# Planning Scheme Amendment C339ggee Flood overlays and zones

## REVIEW OF COMPLEX SUBMISSIONS – LARA, AVALON AND FYANSFORD

City of Greater Geelong

July 2022

## Map 5 - Lara West Growth Area & Manzeene Village

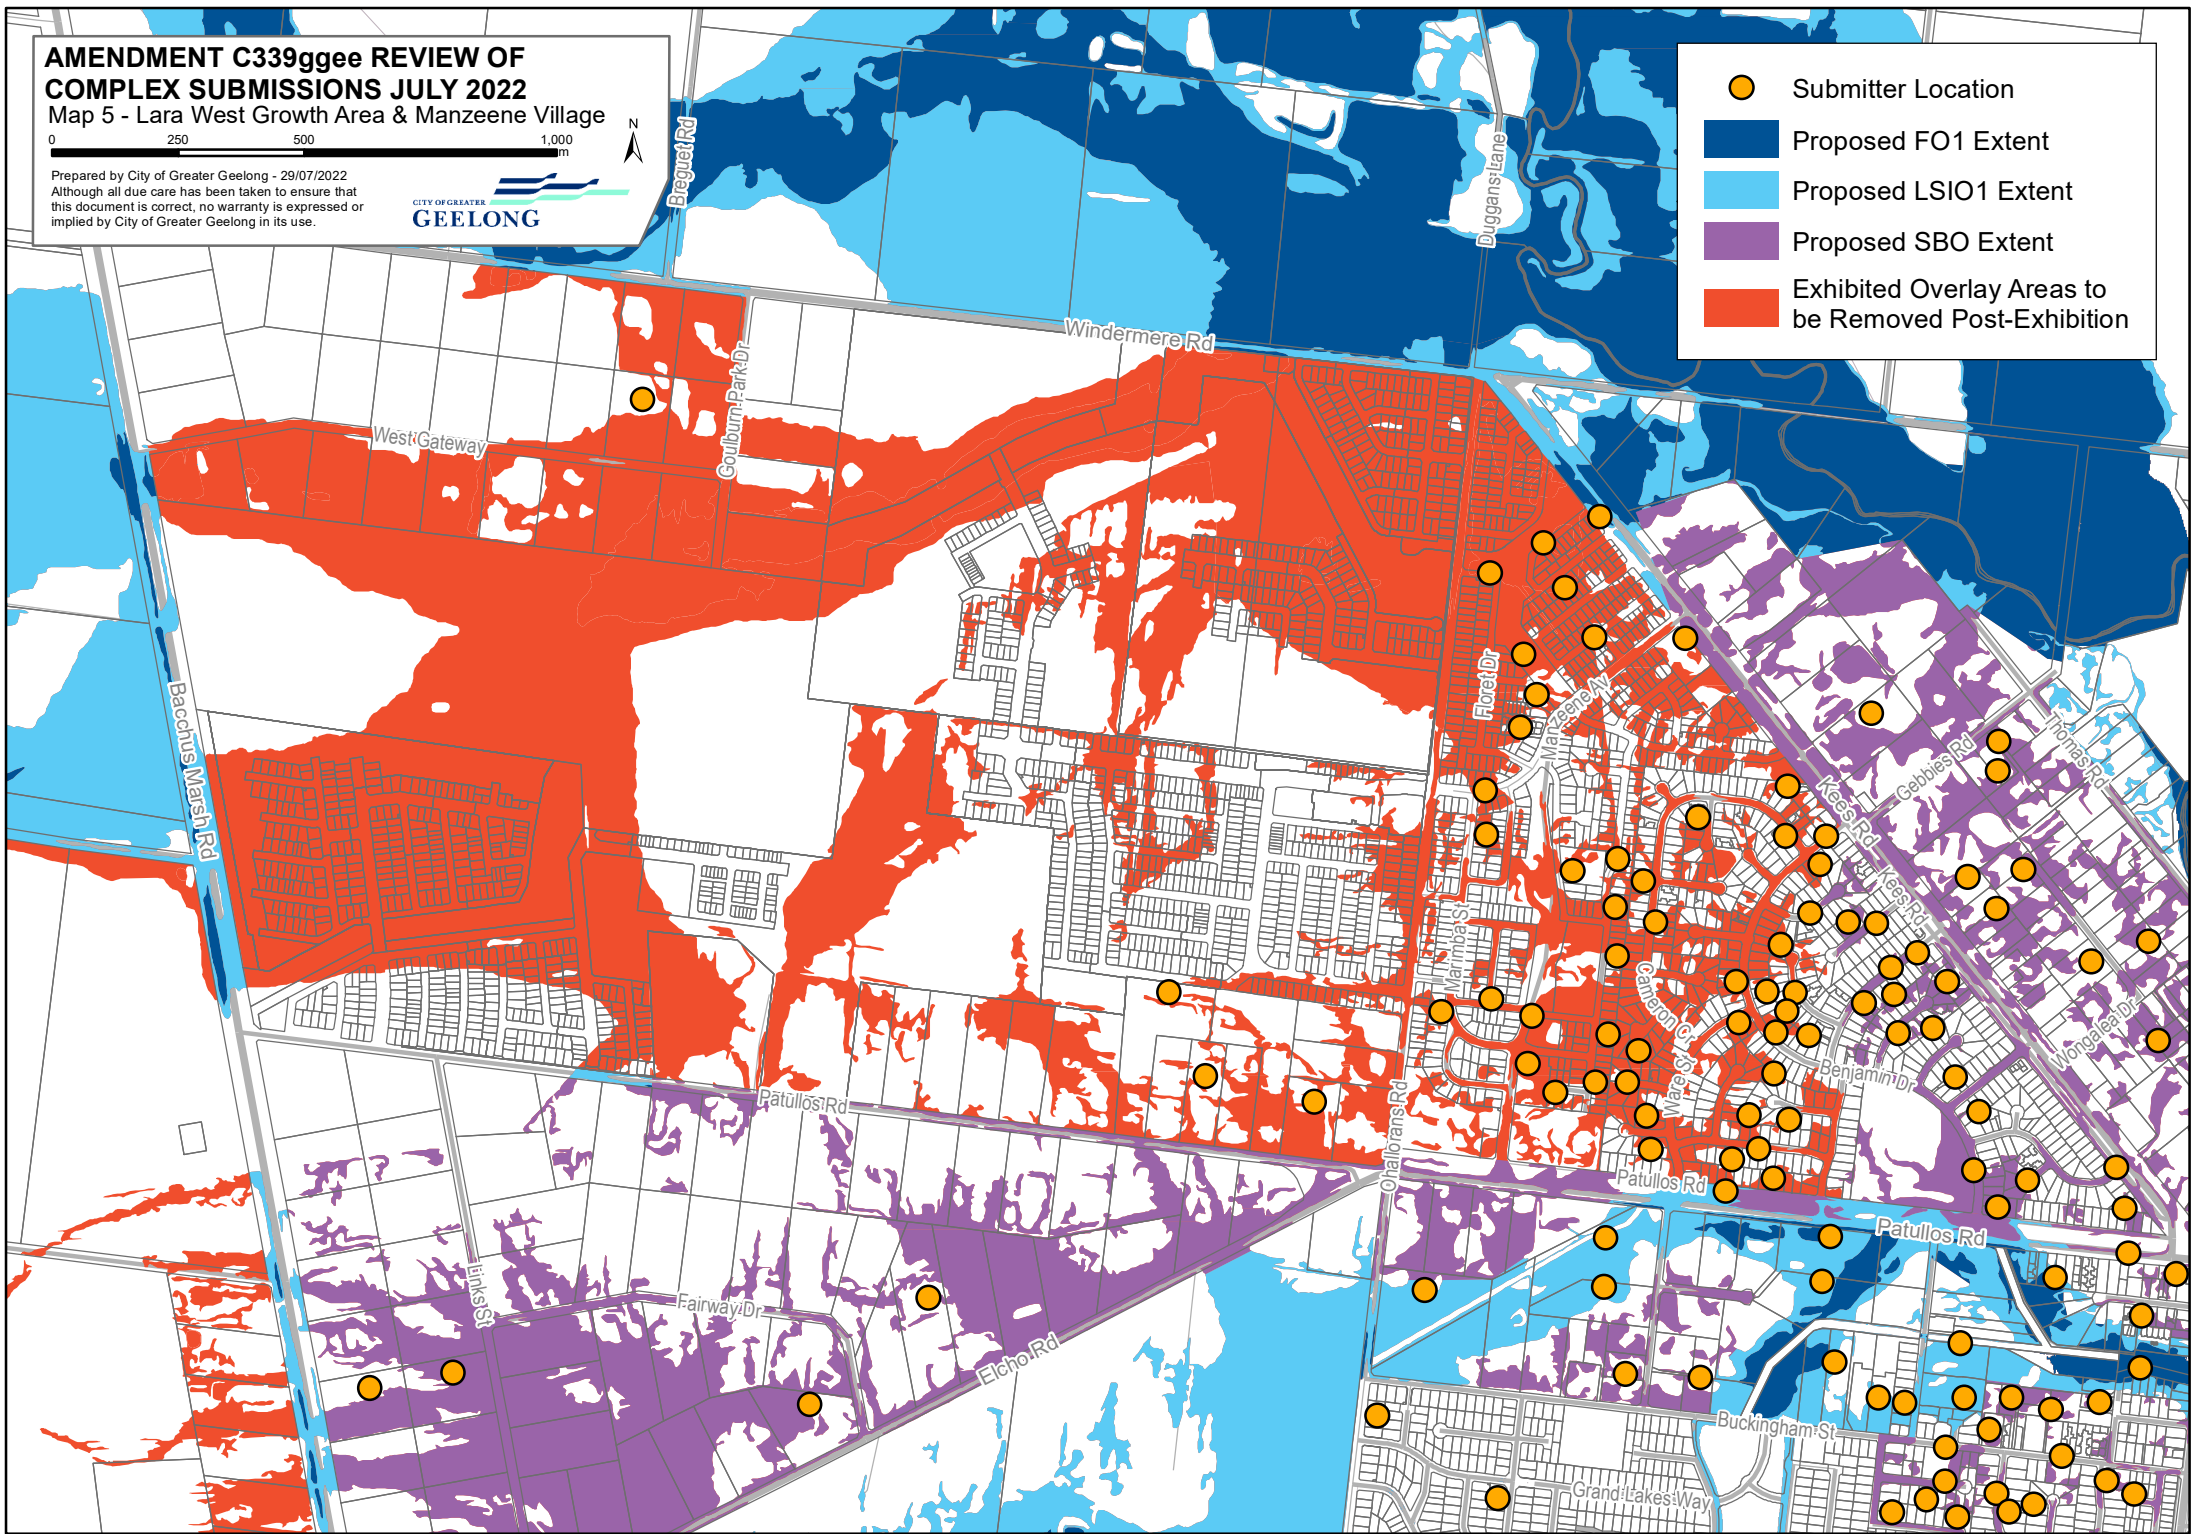
468	Spiire (Consultants) for Austin Land	Austin Estate and 295 Patullos Rd	Lara (Lara West Growth Area)	Water Technology Consultants	LSIO1, SBO	<p>Acknowledges the extensive flood studies undertaken by the City of Greater Geelong and the continued work to implement these studies. As land is within Lara West PSP it is not identified as areas subject to flooding within the Planning Scheme. Flooding issues should be catered for through preparation and approval of PSPs. Contests the need to impose any flood-related planning overlays on the 285 or 295 Patullos Rd given the planning framework already in place. A combination of estate construction, earthworks and</p>	<p><u>Summary of response (see Water Technology Memo 12 May 2022 for full comments):</u></p> <p>As above... The subject area is located within the Lara West Development Precinct. Development within this area is based on the surface water planning and development layout produced as part of the Lara West Precinct Structure Plan. Development within this area has only commenced within the past 2 years.</p> <p>Flood modelling for the Lara Flood Study was based on existing conditions at the time of model development in 2017/2019. This was based on topography and existing stormwater and</p>	Yes - exclude from overlay See Map 5

475	Individual Submitter	West gateway	Lara (Lara West)	<b>Water Technology Consultants</b>	SBO	Wants excluded because property in Lara West PSP.	As per above submissions and responses this land is within the Lara West Growth Area and hence is to be excluded from the amendment.	Yes - exclude from overlay See Map 5
198	Individual Submitter	Floret Drive	Lara (Manzeene Village)	<b>Water Technology Consultants</b>	SBO	Essentially proposes that the Manzeene Village Flood Modelling be adopted.	<p>Summary of response (see Water Technology Memo 12 May 2022 for full comments):</p> <p>The topographic information (Photogrammetry) on which the Lara Study is based was collected in 2017.</p> <p>At this time “Manzeene Village” estate had commenced earthworks but was still in the early stages of development. This means that raised ground levels for areas which had been or were planning to be filled as part of the development were not incorporated into the modelling.</p> <p>Further to this the stormwater network which has been designed for this estate which manages stormwater runoff had also not been completed or incorporated into the flood model.</p>	Yes - exclude from overlay See Map 5

Map 6 - Lara Views Estate

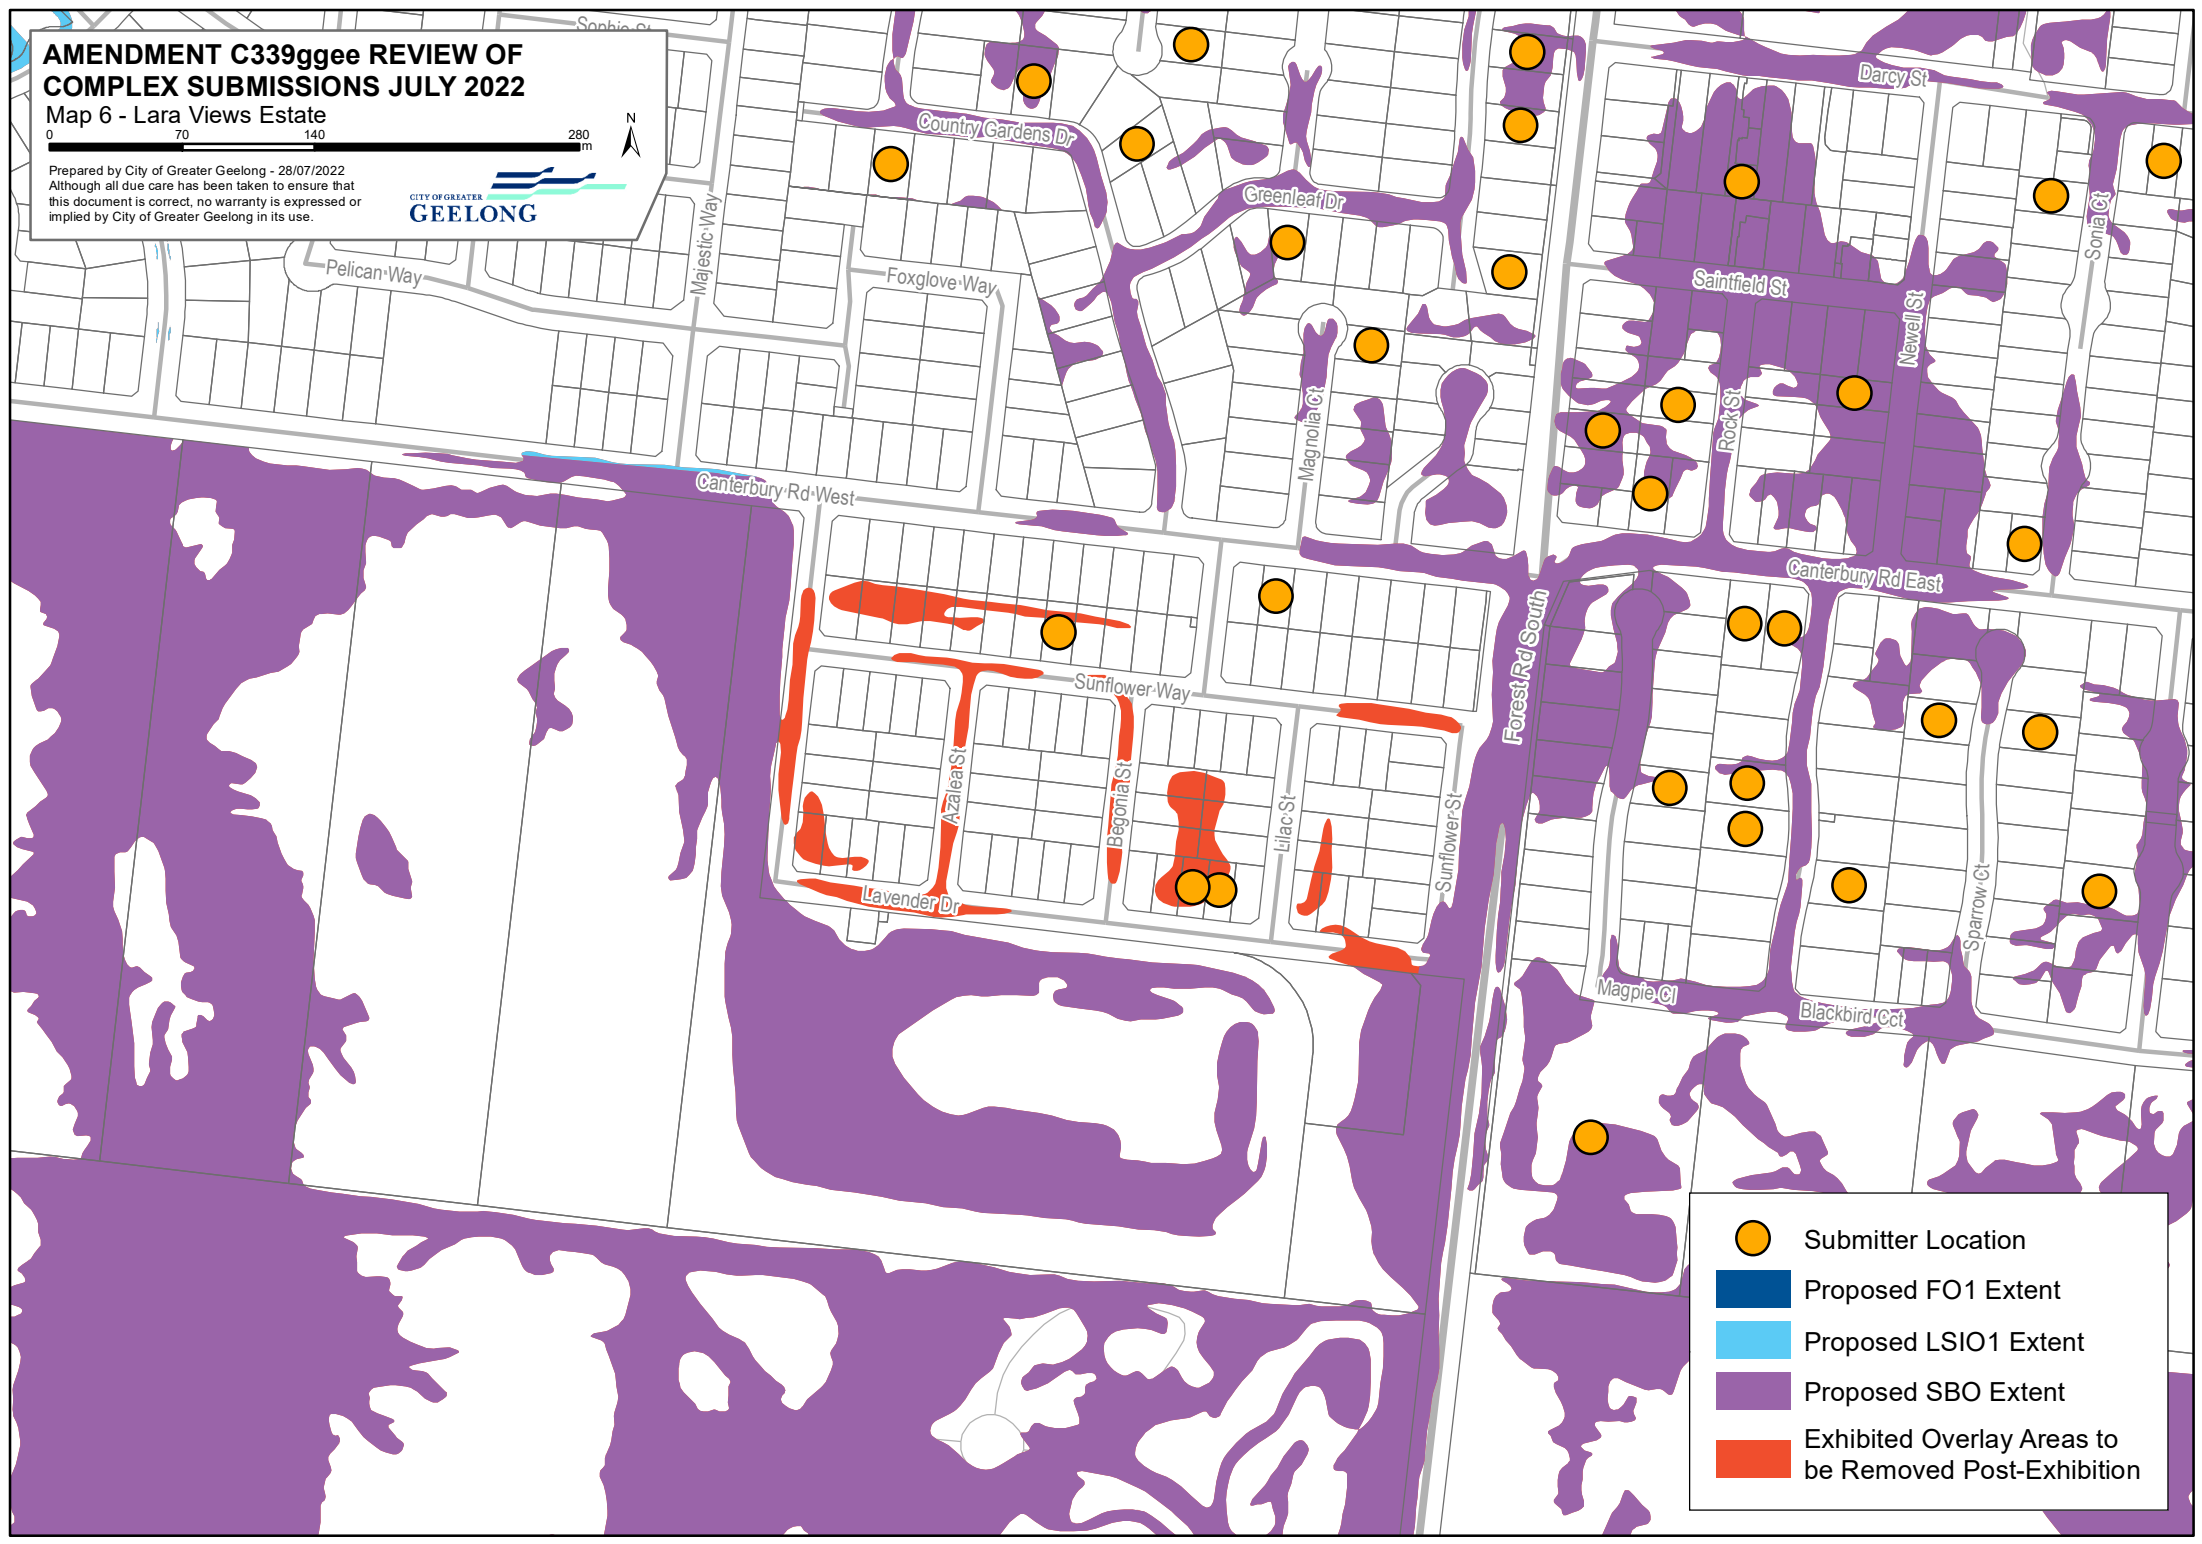
296	Marshall, TGM Cardno (Consultants) for Bisinella	<p>1. Lara Central Estate</p> <p>2. Lara Views Estate</p> <p>3. Lara Lakes Estate (Lara West Growth Area)</p> <p>4. Applegum Estate (Manzeene Village area)</p>	Lara	<b>Water Technology Consultants</b>	SBO, LSIO1, FO1	<p>Submitter's client, L Bisinella Developments Pty. Ltd, notes that it recognises the importance of managing flood risks across the municipality.</p> <p>However, it is submitted that insufficient rigour has been applied in the preparation of the Amendment and that the proposed changes to the Planning Scheme are not soundly based. More detailed site specific analysis needs to be undertaken, including more up to date surveys and assessment of conditions. In its current form, the Amendment should be abandoned.</p> <p>The application of overlays such as the Special Building Overlay (<b>SBO</b>) to land has significant consequences for landowners.</p>	<p>Summary of response (see Water Technology Memo 12 May 2022 for full comments):</p> <p>The following response is in relation to submission 296, located at the following locations listed below and shown in Figure 19 &amp; Figure 20.</p> <ul style="list-style-type: none"> <li>• 130-150 Forest Rd South (Lara Views Estate)</li> <li>• 385 Windemere Road (Lara Lakes Estate)</li> <li>• 43-55 &amp; 60 Manzeene Avenue (Applegum Subdivision)</li> <li>• 21 Caddys Road, 131 Flinders Avenue &amp; 135 Flinders Lane (Lara Central Estate)</li> </ul> <p>The main issue relating to each of the areas is the exclusion of more up-to-date information to reflect the development which</p>	<p>Yes - exclude from overlay</p> <p>See Maps 4, 5, 6</p>
